MIL-C-50652/12(MU)
AMENDMENT 2
18 September 1974
SUPERSEDING
AMENDMENT 1
7 June 1973

MILITARY SPECIFICATION
CIRCUIT CARD ASSEMBLY: 10548086
(INTEGRATOR, RATE)

This amendment forms a part of Military Specification MIL-C-50652/12(MU), dated 15 April 1971, and is approved for use by all Departments and Agencies of the Department of Defense.

FIGURE 1A △R OUTPUT SIGNALS

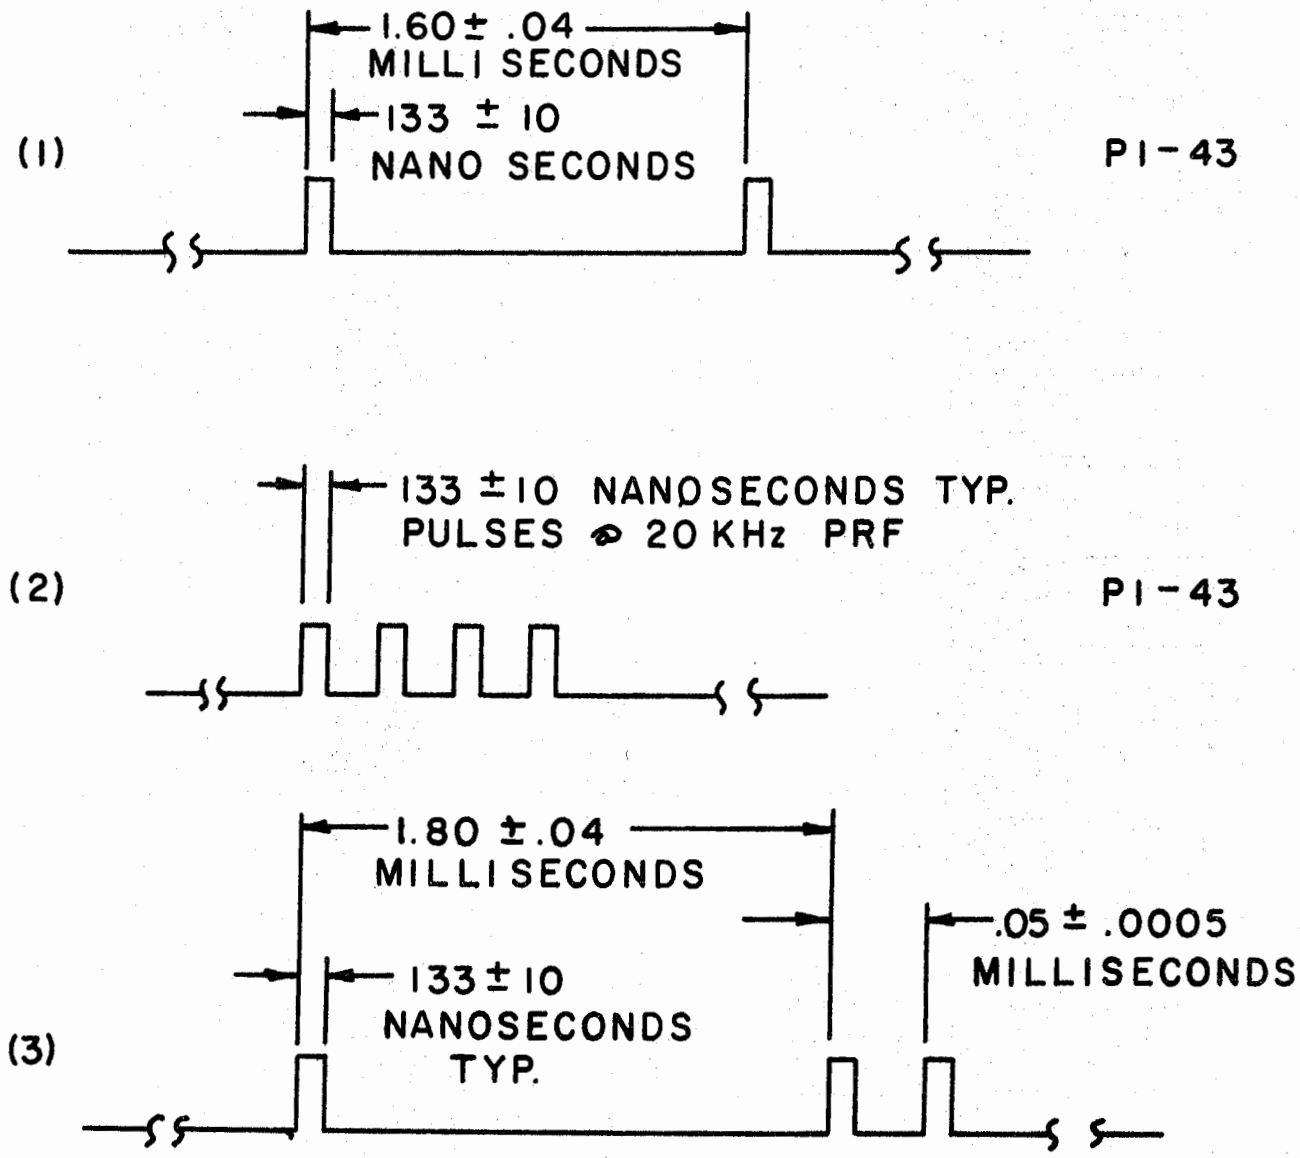
Following Figure 1, add new Figure 1A.

FIGURE 3. SIGNAL GENERATOR AND TIMING CIRCUIT.

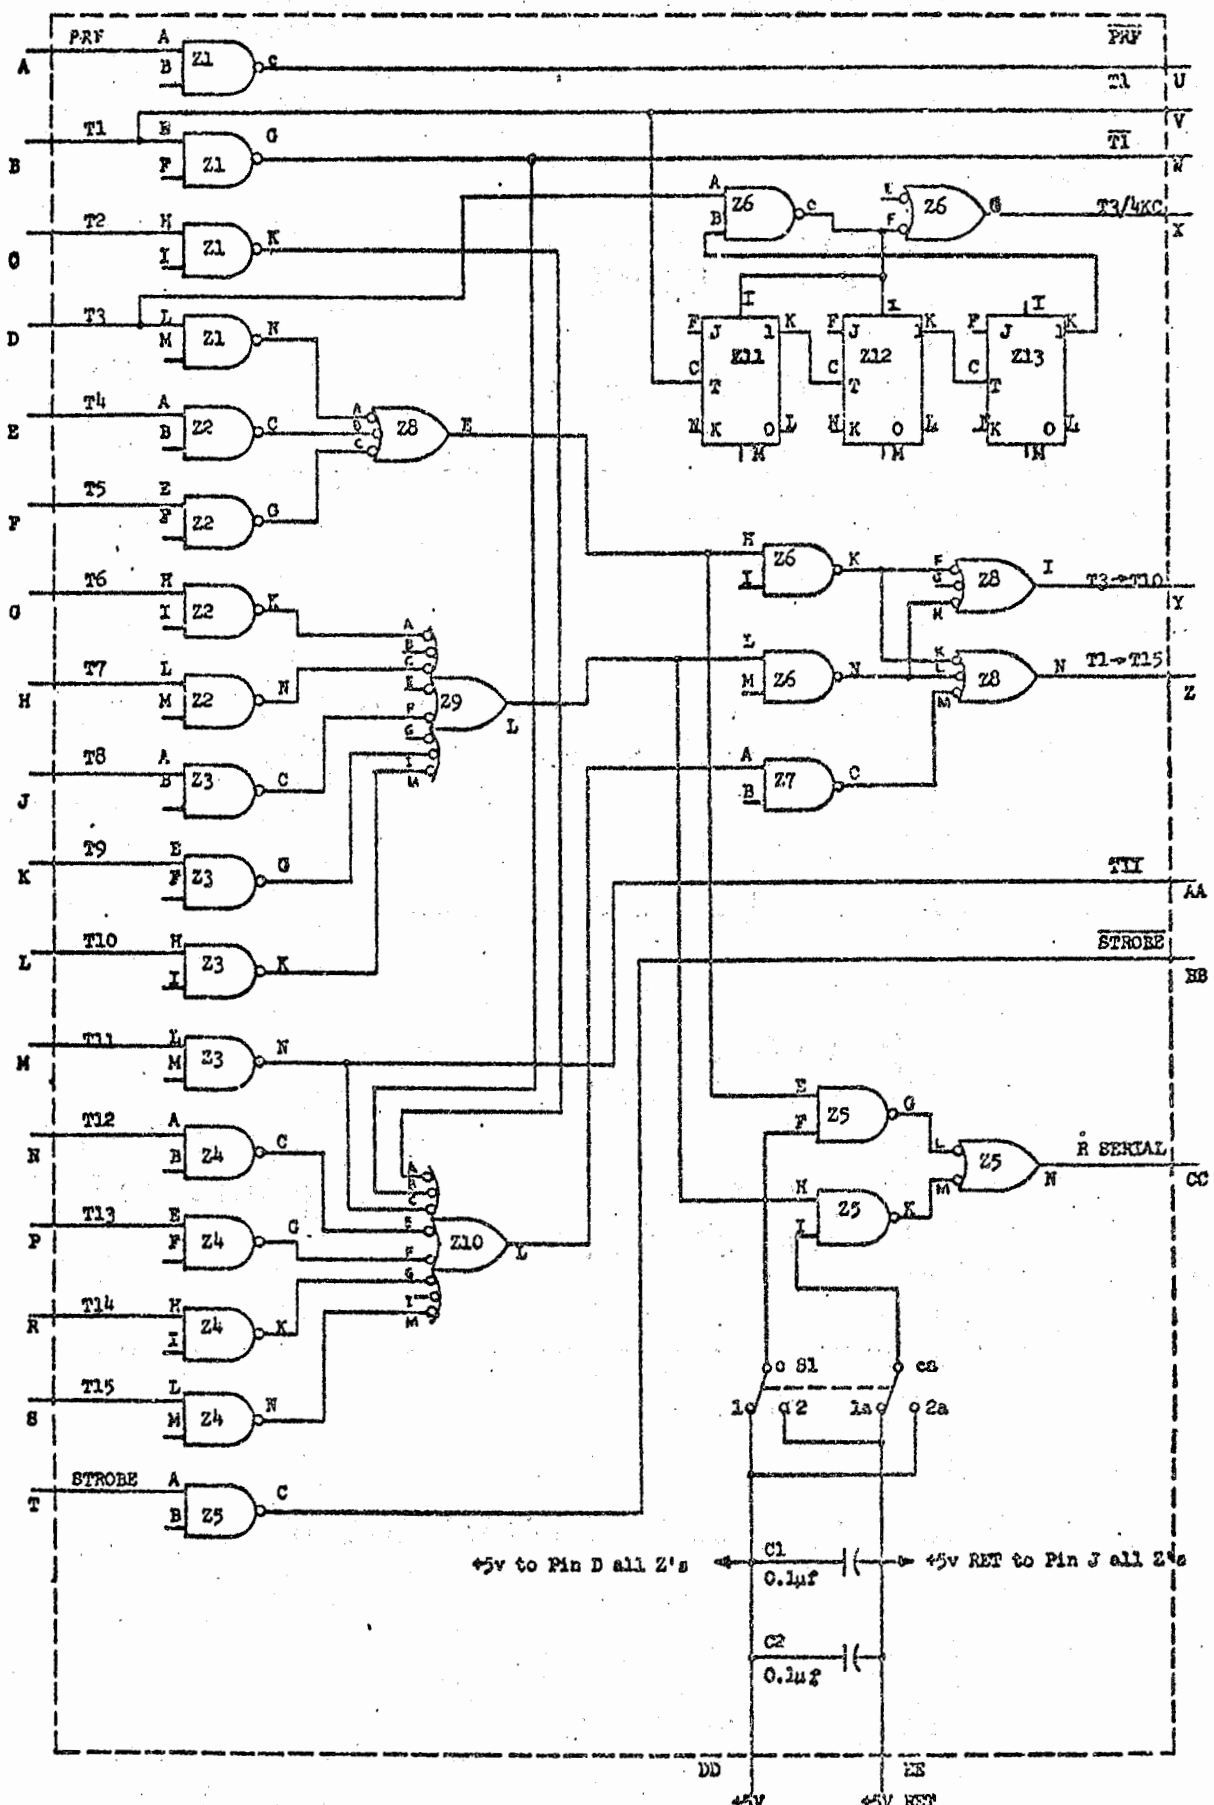
* Figure 3: Delete in its entirety and substitute new Figure 3, attached.
